Maine Yankee

RA-05-028
Proposed Change No. 218, Supplement 24

Subject: License Amendment Request: Release of Non-ISFSI Site Land

Legal Description
Independent Spent Fuel Storage Installation Site
Maine Yankee - Wiscasset, Maine

DRAWING NAME **FIGURE 1**

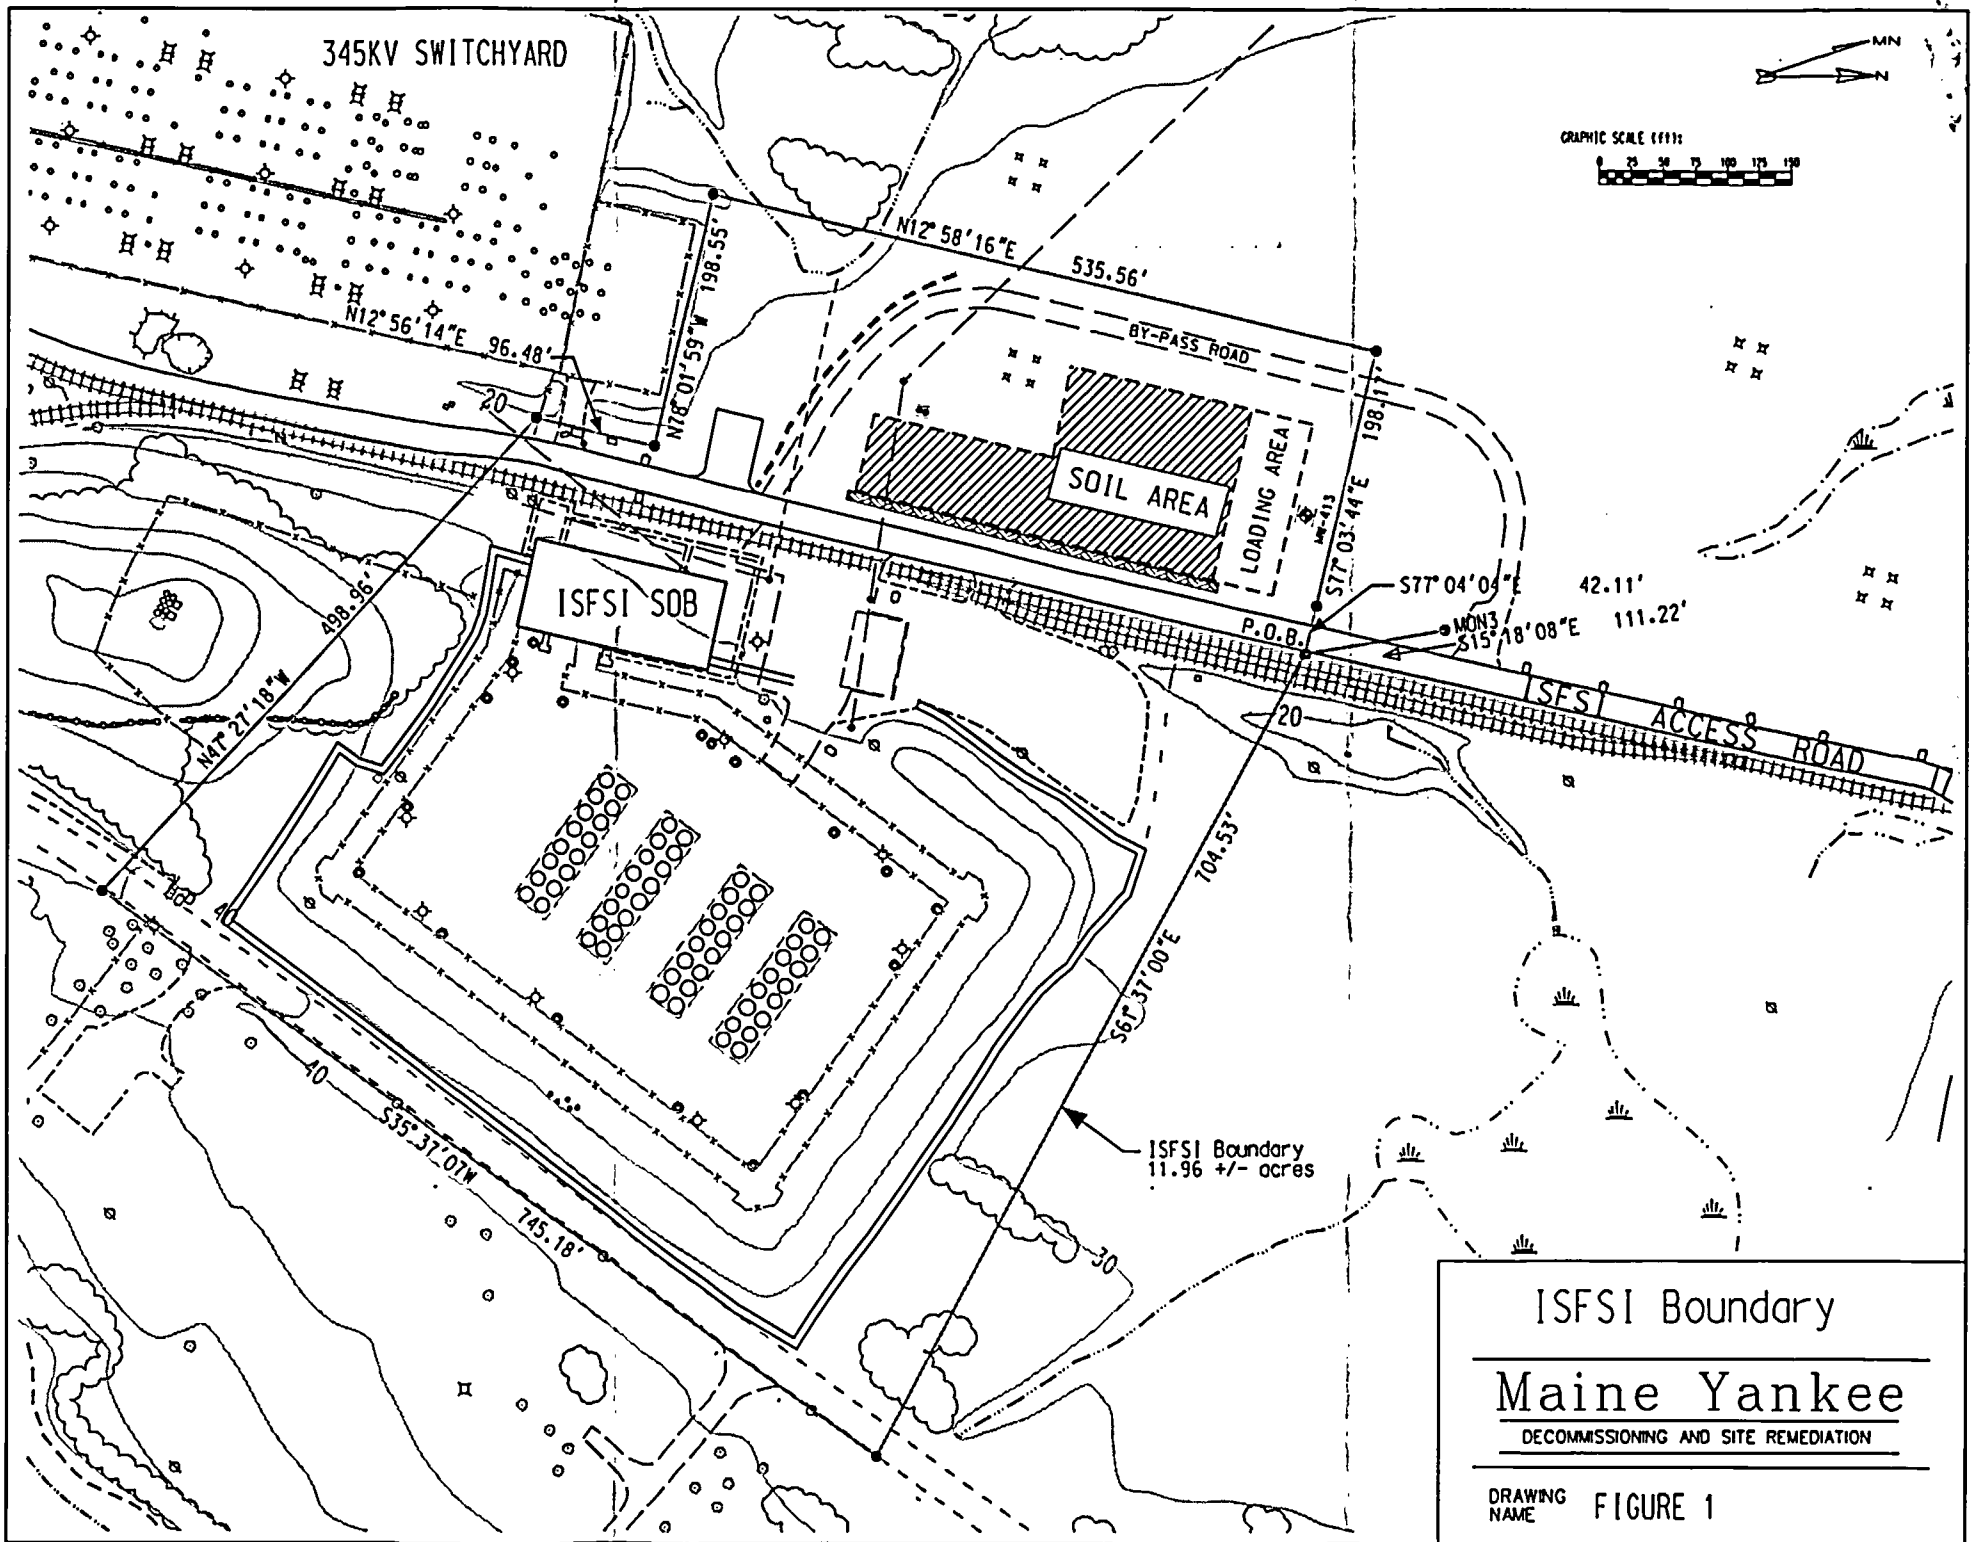
Maine Yankee hereby supplements its request for amendment (Reference No. 2) to the facility operating license (Reference No. 1) by withdrawing approximately 3.17 acres from the land to be released and by keeping that land under the jurisdiction of the license. The increase in land area to remain under the license will provide additional onsite space for future cask handling operations and for temporary placement of excavated soil awaiting offsite shipment and disposal. Accordingly, attached is a revised legal boundary description of the Maine Yankee ISFSI site and Figure 1, ISFSI Site. This revised description replaces the description of the Maine Yankee ISFSI site supplied in Reference No. 2, Attachment I, Section 4.1 and Attachment III:

A certain lot or parcel of land with improvements thereon situated at the former Maine Yankee Atomic Power Generation site in the Town of Wiscasset, Lincoln County, Maine.

Commencing at an aluminum disk labeled "Mon 3" on a plan entitled "ISFSI Grading Plan", prepared by Stone & Webster Engineering Corporation Denver, Colorado, Drawing Number 0819616-EY-3A-6, last noted revision 12-3-02, thence:

- S 15°18'08" E A distance of one hundred eleven and 22/100 feet (111.22') to a 5/8" rebar set with a yellow cap labeled "SGC PLS2294" being the point of beginning, thence;

- S 61°37'00" E A distance of seven hundred four and 53/100 feet (704.53') to a 5/8" rebar set with a yellow cap labeled "SGC PLS2294", thence:
- S 35°37'07" W A distance of seven hundred forty five and 18/100 feet (745.18') to a 5/8" rebar set with a yellow cap labeled "SGC PLS2294", thence:

- N 47°27'18" W A distance of four hundred ninety eight and 96/100 feet (498.96') to a 5/8" rebar set with a yellow cap labeled "SGC PLS2294", thence:
- N 12°56'14" E A distance of ninety six and 48/100 feet (96.48') to a 5/8" rebar set with a yellow cap labeled "SGC PLS2294", thence:

- N 78°01'59" W A distance of one hundred ninety eight and 55/100 feet (198.55') to a 5/8" rebar set with a yellow cap labeled "SGC PLS2294", thence:
- N 12°58'16" E A distance of five hundred thirty five and 56/100 feet (535.56') to a 5/8" rebar set with a yellow cap labeled "SGC PLS2294", thence:

- S 77°03'44" E A distance of one hundred ninety eight and 17/100 feet (198.17') to a 5/8" rebar set with a yellow cap labeled "SGC PLS2294", thence:
- S 77°04'04" E A distance of forty two and 11/100 feet (42.11') to the point of beginning.

The above-described lot contains 11.96 acres, more or less.
